PLUMBING AND MECHANICAL
INTERPRETATION MANUAL

CODE REF: IRC 2803.6.1 & IPC 504.6.1

SUBJECT: Pan and T & P Relief Drains PAGE 1 of 2

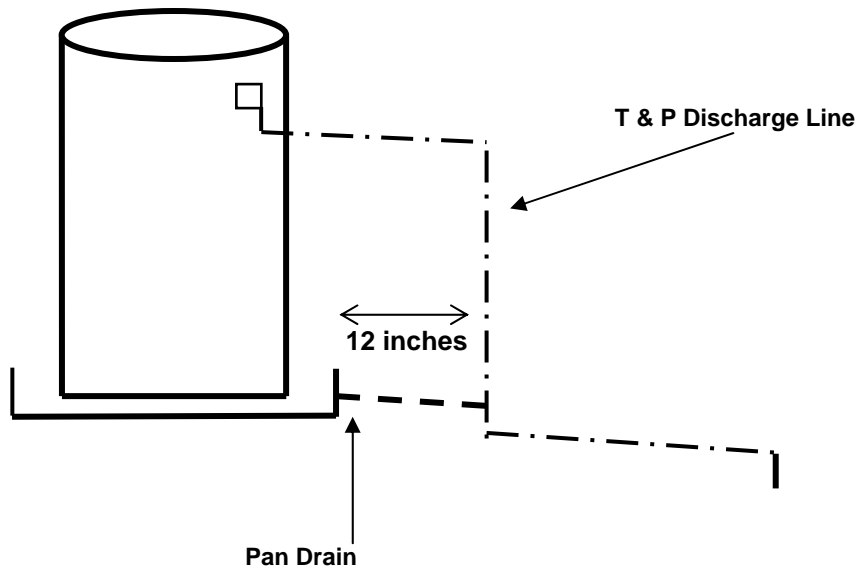
Question: Can the T&P drain and water heater pan drain be connected together when there is not anyway to run as separate pan-drain and T&P discharge line to the outside?

There are times when because of the age or design of the structure in which a water heater is installed that it may not be possible to have a separate T&P and pan-drain discharge line. The contractor could install a "Waggs Valve" if the water heater utilizes gas as a fuel source, but if the water heater is electric the "Waggs" is not designed work with an electric water heater. By installing a "Waggs" this will increase the cost to the consumer without necessarily providing any greater level of safety. Therefore, if there is no other way to install a separate T&P drain line and a separate drain-pan drain line to an approved location the T&P and pan drain may be connected together utilize the same drain line and run to an approved point of disposal. A swing check valve will not be required on the pan-drain line; however, the connection from the T&P to the common discharge line should be made in a manner to minimize the possibility of discharge water from flowing back into the drain-pan. See illustration below.

The T&P discharge line may not terminate in the pan. The point of connection of the T&P and the pan drain should be 12" from the drain pan if possible. If possible the pan drain should be connected to the branch of a tee and the size of the combined discharge line should be no less than 3/4 inch or the size of the T&P discharge outlet.
